Option A / more room for people

SMC02 develops the earlier study. 100 congregation positions and the S01 architectural identity remain fixed requirements.

C02 brief P03 reference Open source decisions

K2 / six broader rows

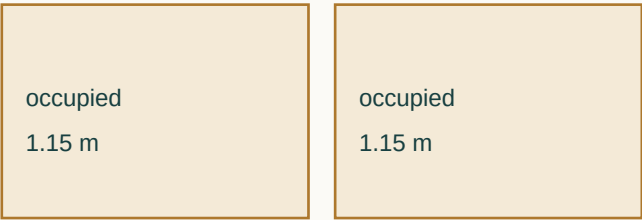
Rearranging the same 92 standard positions into six rows produces a minimum corner-to-corner gap of 0.495 m between adjacent row envelopes. The protected central band remains 1.80 m; the calculated standard-envelope gap at its narrowest point is 2.24 m. The model uses 0.45 m as a comparison target for row passage, not as a code determination.

RADIAL COMPARISON / NTS

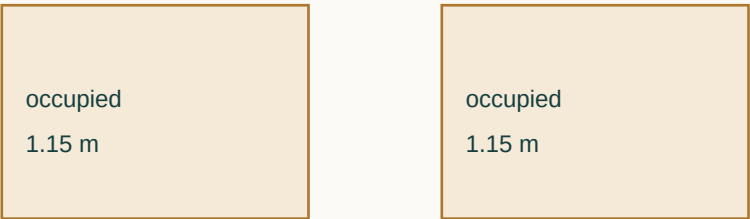
K0 / 1.25 m pitch

K2 / 1.65 m pitch

The actual test uses rotated chair polygons, so the narrowest gap is slightly below simple pitch minus depth. Both row ends connect to the aisle system in A2; the architect must verify row access length, clear width and chair linking.

A2 / MOVE THE ROOM BOX

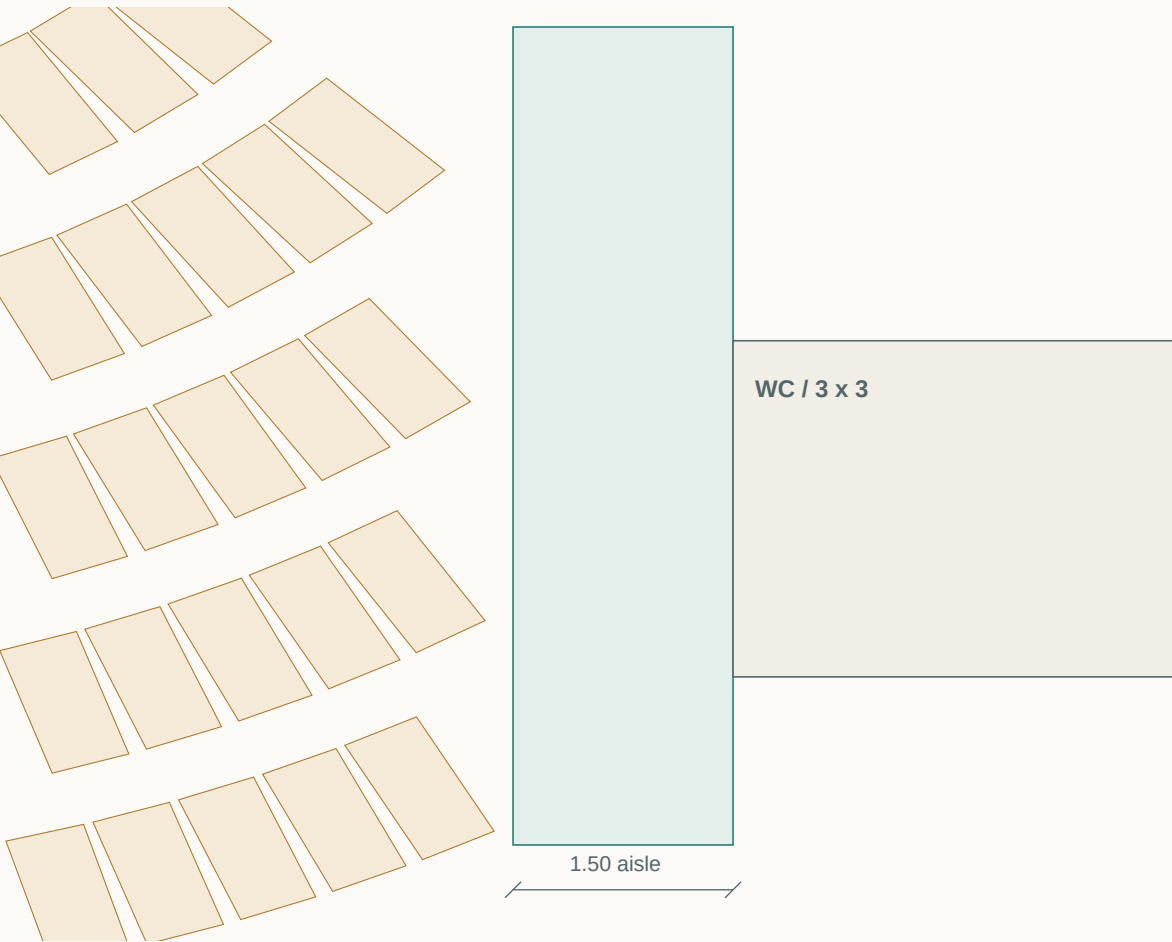
Room moves 1.00 m outward and 1.50 m toward the sanctuary. Its inner-side door remains a nominal 1.00 m study opening, with hardware and usable width unresolved. The new room corner sits about 0.22 m inside the old graphic inner circle.

The 3 x 3 m box is a spatial reserve, not verified net clear WC space. Wall build-ups, toilet transfer/turning spaces, plumbing, privacy, windows, overhead fixtures and ventilation may change this result.

A3 / RETAIN THE ROOM BOX

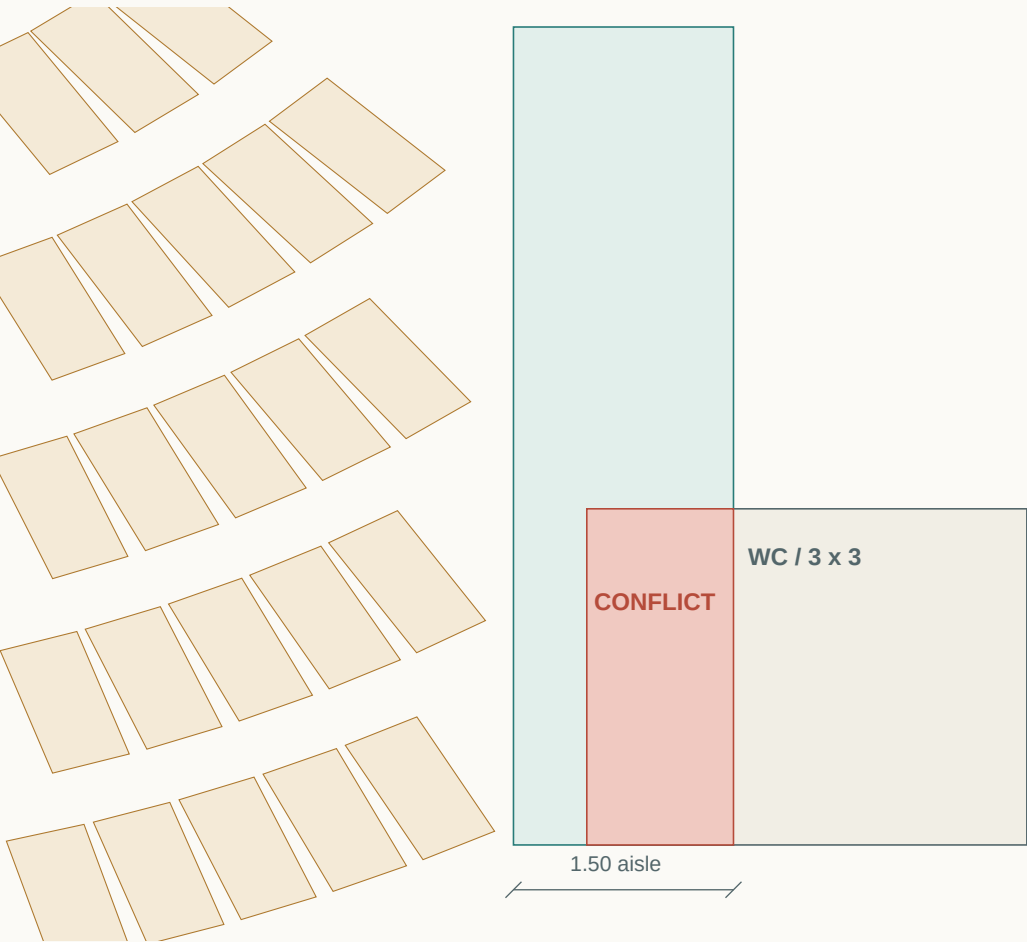
A top-wall door could be studied while retaining this footprint, but the room still blocks the continuous outer aisle. Do not count an open row end as a second route unless its onward path is established. Eight-seat half-rows need specific professional review.

The 3 x 3 m box is a spatial reserve, not verified net clear WC space. Wall build-ups, toilet transfer/turning spaces, plumbing, privacy, windows, overhead fixtures and ventilation may change this result.

T1 / freestanding tabernacle pedestal

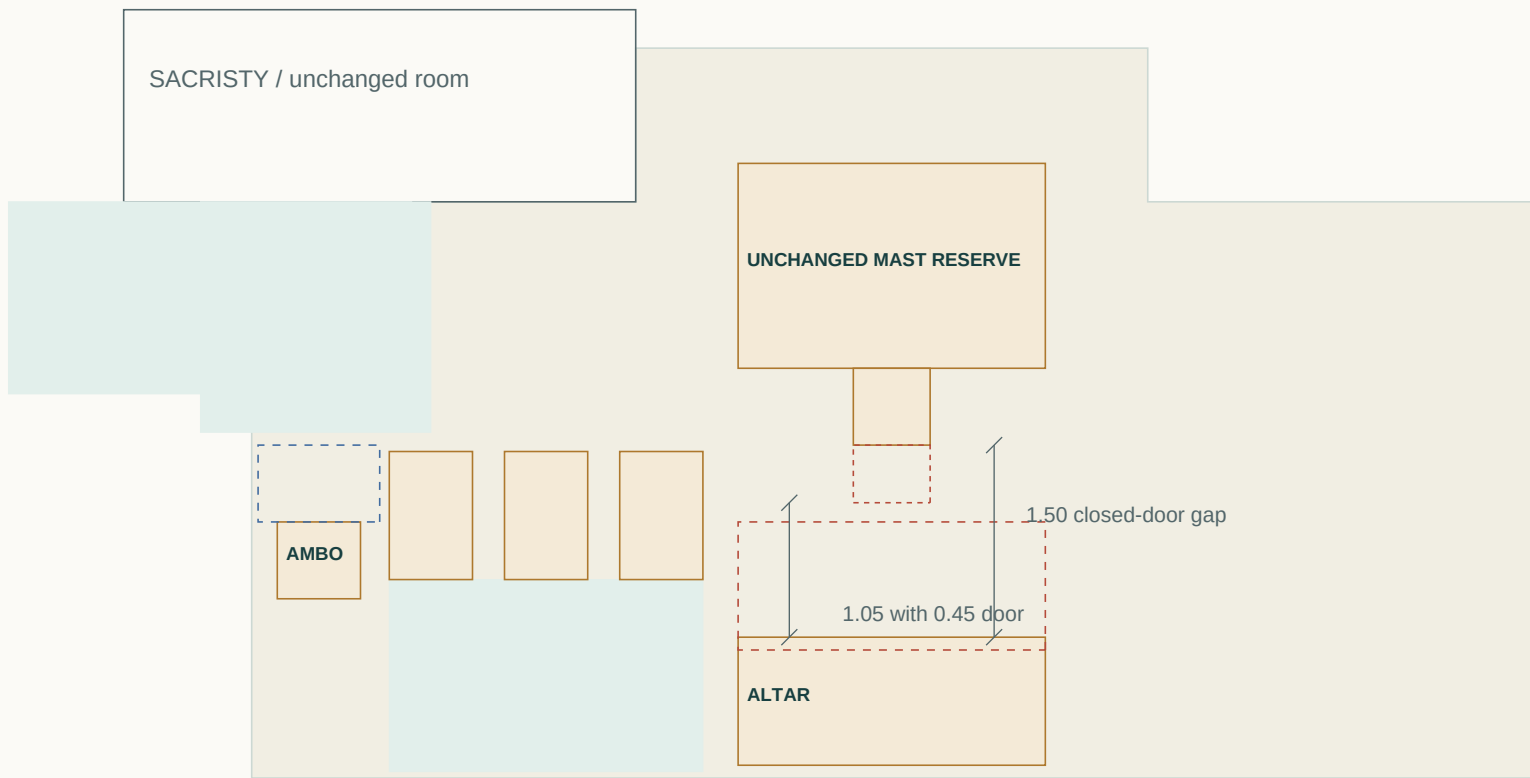
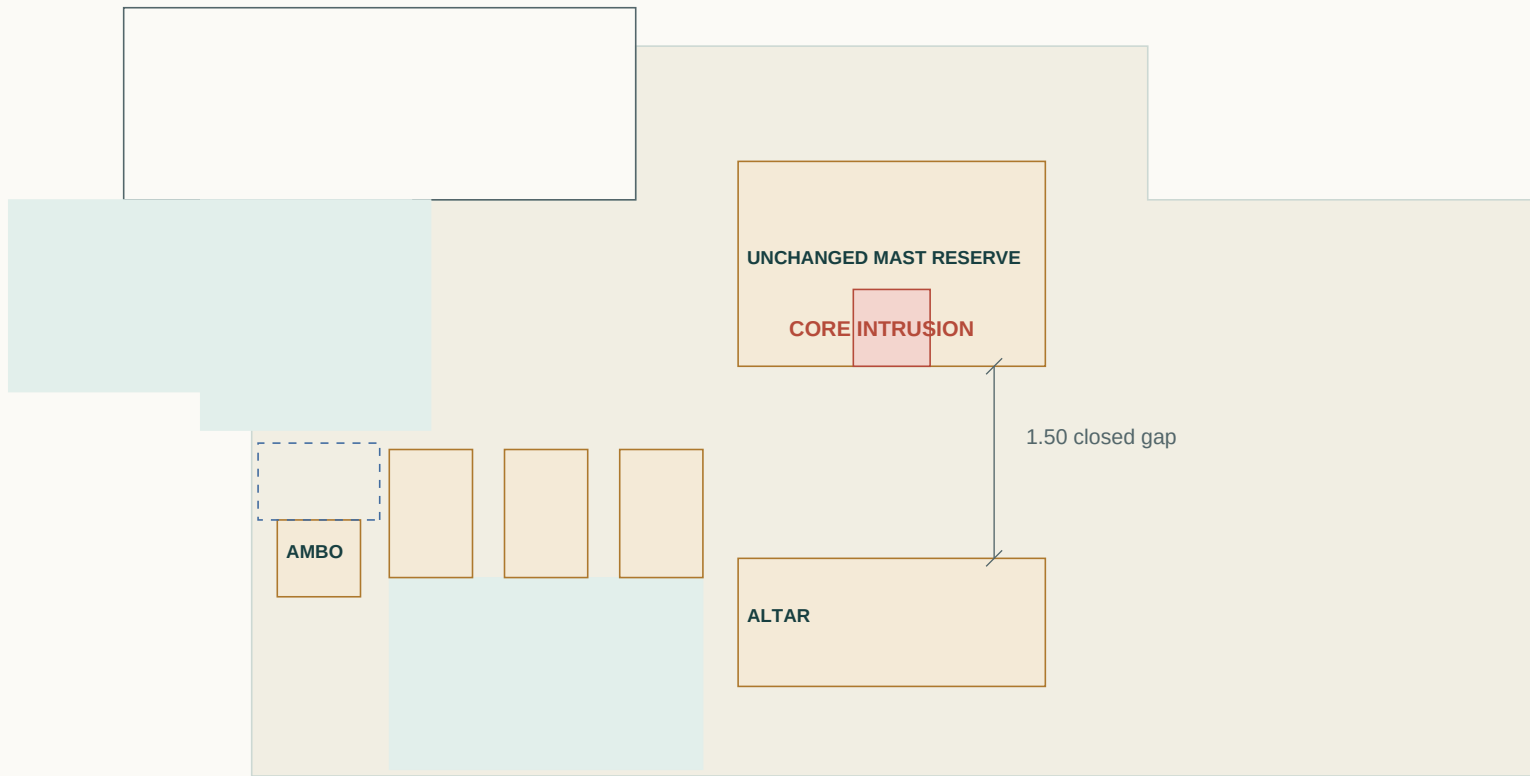
Keep the mast reserve intact. Move the altar forward 0.90 m from P03, then test real liturgical use.

Dashed red altar outline = P03 position. Red rectangle = hypothetical open tabernacle door. No door size, sacred-furniture product or Church permission is assumed to be selected.

Retain the 2.40 x 1.60 m mast reserve at y6.20-7.80. Test a 0.60 x 0.60 m pedestal at y5.60-6.20. Move the 2.40 x 1.00 m altar from y4.00-5.00 to y3.10-4.10. The clear closed-door gap becomes 1.50 m.

A hypothetical tabernacle door projecting 0.45 m into this gap leaves 1.05 m along that central line. A person standing at the tabernacle consumes further space. The 1.50 m figure does not prove simultaneous through-circulation and tabernacle use.

Measure the actual door, pedestal, user reach and ritual movements. Test access from the right and front of the pedestal without using the 0.80 m mast-to-room slot as a circulation route. Keep lamp and flowers out of the tested working space.

T2 / mast-integrated alternative

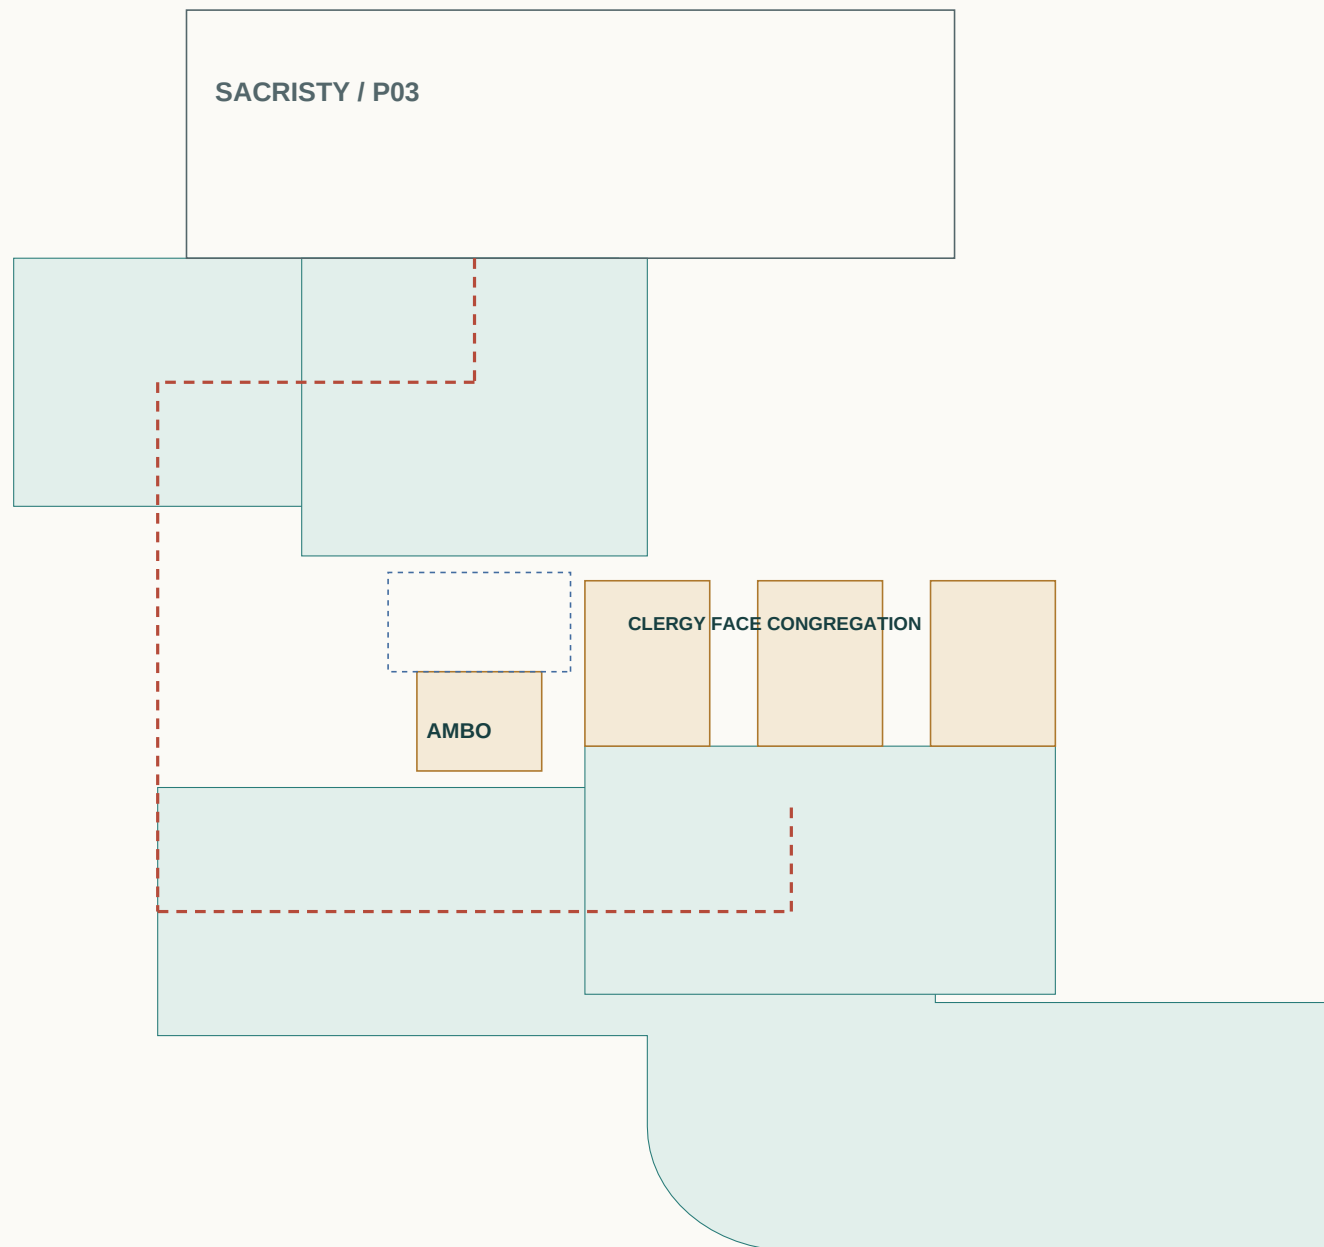
A smaller altar move preserves more of the existing composition, but requires a new structural and furniture solution.

T2 is not combined with T1. Its shaded intrusion deliberately marks a dependency, not a solved construction detail. Open-door and occupied-use checks still apply.

Move the altar only 0.30 m forward from P03, to y3.70-4.70. Put the pedestal/tabernacle support within a proposed recess at the mast front, y6.20-6.80. This gives 1.50 m to the mast-front line when closed.

The P03 mast is a structural reserve, not an empty cabinet. The red support volume overlaps that reserve by 0.36 m2 in plan. No cutting, hollowing or reduction of the mast is authorized. The structural engineer must first establish whether any such recess is possible.

Preserve the substantial mast, central Guadalupe image and cross, material expression and roof connection. A flush or recessed solution must be developed behind that appearance; it must not turn the mast into a thin decorative panel.
